UNITED STATES PATENT AND TRADEMARK OFFICE

Office Action Summary	Application No. 10/538,515	Applicant(s) WALDNER ET AL.	
	Examiner RACHEL T. YOUNG	Art Unit 3771

DETAILED ACTION

Fig. 8

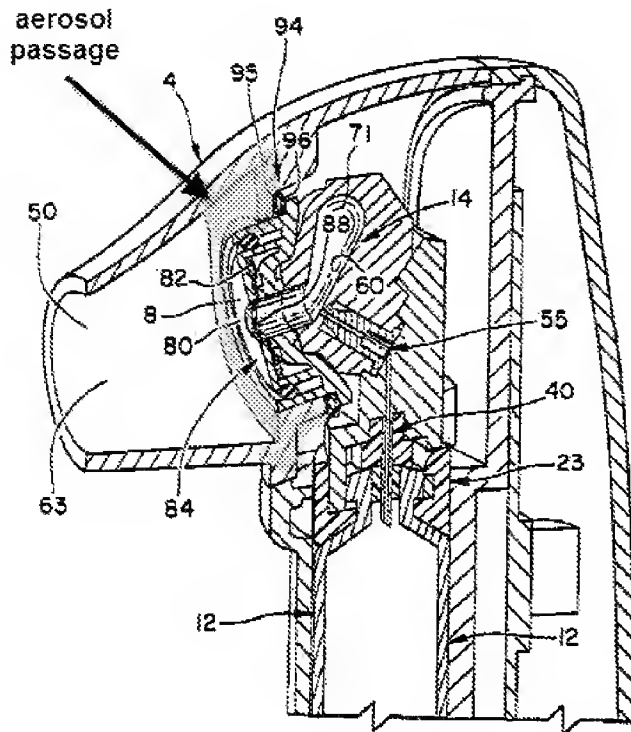
As to claim 1, in fig. 8 Patel discloses an inhalation therapy device comprising an aerosol membrane generator 2 having a liquid storage container 14 into which a liquid (Fig. 9) that can be used for therapy is fillable (Fig. 9), having a membrane 88 which is connected on one side with the liquid storage container such that a liquid disposed in the liquid storage container contacts one side of the membrane, and having an oscillation generator 8 for generating oscillations by means of which a liquid disposed in the liquid storage container is nebulised (Col. 2, ll. 45-50, Col. 4, ll. 66-67-Col. 5, ll. 1-9) into an aerosol through openings (90, Fig. 7) in the membrane (88, Col. 5, ll. 3-9) to the other side of the membrane, a mixing chamber 63 into which the aerosol membrane generator generates the aerosol, having an aerosol passage (see Fig. 8 below), via which the aerosol generated by the membrane generator arrives in the mixing chamber (Col. 4, ll. 62-65), the aerosol passage being disposed with one section on a surface of the aerosol membrane generator so as to surround the membrane along at least one sealing line (Col. 5, ll. 28-29) and extending in an opening manner into the mixing chamber, having at least one breathing air through opening 10 disposed in the region around the aerosol passage (Fig. 1). Patel discloses an aerosol passage and a

breathing air through opening, but is silent regarding an inhalation valve disposed in the region around the aerosol passage that opens the breathing air through opening during inhalation and closes the breathing air through opening during exhalation. However, Denyer teaches an inhalation valve (Fig. 2, 94 Fig. 11) disposed in the region around the aerosol passage (Fig. 2) that opens a breathing air through opening (Fig. 2) during inhalation and closes the breathing air through opening during exhalation (Col. 10, ll. 61-63). Therefore, it would have been obvious to one of ordinary skill in the art at the time the invention was made to substitute Patel's region around the aerosol passage with an inhalation valve and breathing air through opening disposed in the region around the aerosol passage that opens a breathing air through opening during inhalation and closes a breathing air through opening during exhalation, as taught by Denyer, for the purpose of entraining air only during inhalation to protect the nebulizer from contaminants. The modified Patel's region around the aerosol passage has a wall section of the mixing chamber (Denyer, Fig. 2, Patel, Fig. 6)

Regarding claim 5, the modified Patel's nebulizer discloses that the aerosol passage is pipe-shaped (see Fig. 8 above) and the valve element is annular (Denyer, Fig. 2, Patel Fig. 1) and the valve element accommodates the pipe-shaped aerosol passage in the annular opening (Denyer, Fig. 2, Patel Fig. 1).

Regarding claim 7, the modified Patel's nebulizer discloses a pipe-shaped aerosol passage that is formed by a cylindrical sleeve (walls of aerosol passage in Fig. 8 above), provided on the outer surface of which is a region (Denyer, 3 Fig. 2, Patel Fig. 1) accommodating the breathing air through openings (Denyer, Fig. 2, Patel Fig. 1), which extends essentially perpendicular to the longitudinal axis of the sleeve (Denyer, Fig. 2, Patel Fig. 1).

Regarding claim 8, the modified Patel's nebulizer discloses that the cylindrical sleeve is disposed concentrically to the membrane (see Fig. 8 above).

Regarding claim 10, the modified Patel's nebulizer discloses that the aerosol passage comprises a bulge (Patel, 84, Fig. 8) in the area facing the membrane.

Regarding claim 11, the modified Patel's nebulizer discloses that the one or more breathing air through openings extend essentially parallel (Denyer, Fig. 2, Patel Fig. 1, Fig. 8 above) to the aerosol passage.

Regarding claim 12, the modified Patel's nebulizer discloses that the breathing air through openings extend in a spiral manner (Denyer, Fig. 2, Patel Fig. 1, Fig. 8 above) in relation to the aerosol passage.

Regarding claim 13, the modified Patel's nebulizer discloses that the one or more breathing air through openings are configured as circular ring sections (Denyer, Fig. 2, Patel Fig. 1, Fig. 8 above).

Regarding claim 17, the modified Patel's nebulizer discloses that the region (Denyer, Fig. 2, Patel Fig. 1, Fig. 8 above) of the one or more breathing air through

openings is disposed essentially on a plane with the membrane (Denyer, Fig. 2, Patel Fig. 1, Fig. 8 above).
